Access Compliance Report

Public Rights-of-Way

(Curb Ramps)

Intersection ID: 3145	Main Street: BASKERVILLE_AV	Cross Street: PALLADIUM_PL	Location: E
ADA ID: BC0E1F6FD35F	Ramp Type: Perp	Initial Pass/Fail: Pass	Overall Compliance: No
Severity Score: 10			
Codes/Mitigation Info/Possible Solution		Field Measurements/Component Compliance

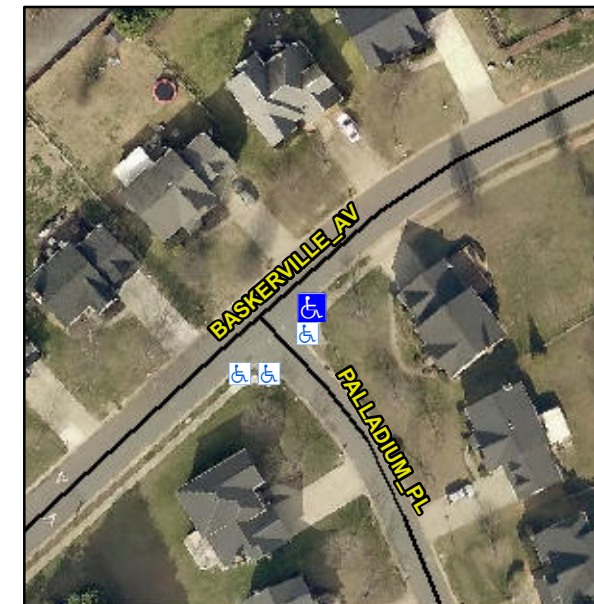
Remove & Replace Entire Ramp.

R304.5.3, R305
